Dear Editor and the reviewer,

Response to General comments:

Figure 7: Digital Elevation Model (DEM): a) SRTM Original; b) SRTM Calibrated.

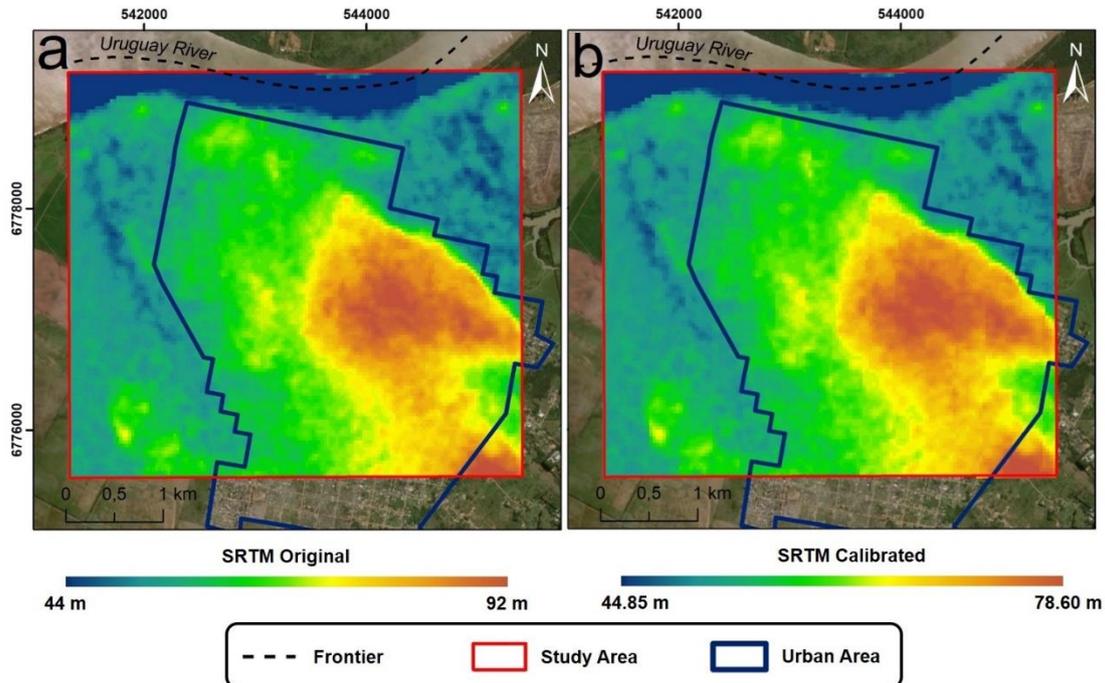
9) [Anonymous Referee #2]: In my opinion, a figure showing a comparison between original and calibrated DEM (with the same colour scale range) would be useful to better understand the improvements coming from the DEM's calibration.

[Authors's answer]: A figure was drawn up and included in the new text (figure 7).
